**Total Maximum Daily Load
To Address Biological Impairment in
Stevens Brook (VT05-07)
Franklin County, Vermont**

October 2008

Appendix A: Summary of Responses to Public Comments

Figure 5. High flow portion of the flow duration curves for Stevens Brook and attainment stream.

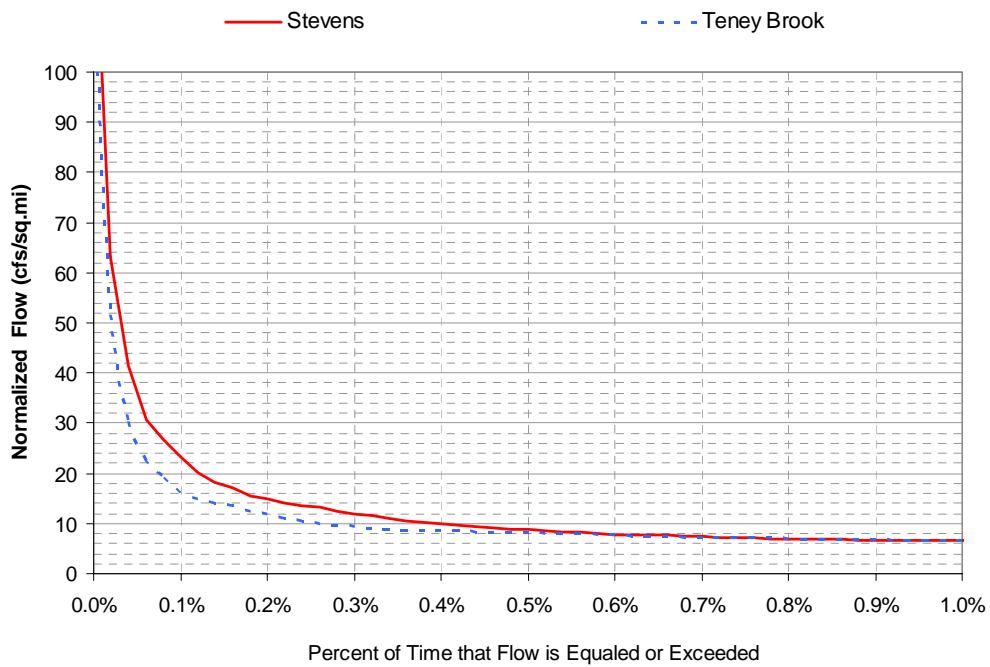
4. Page 14. The coincident of the graphs in Figure 5 does not seem to support a significant expenditure of resources to reduce stormwater related flows in Moon Brook. [Rutland]

Response: As noted in the TMDL, the high flow reduction target from current modeled conditions is 12%. Across the spectrum of the stormwater impaired streams for which TMDLs have been developed, this percent flow reduction is relatively modest. However, at this time watershed-specific implementation planning and cost estimates have not been developed to estimate the resources required to achieve this target.
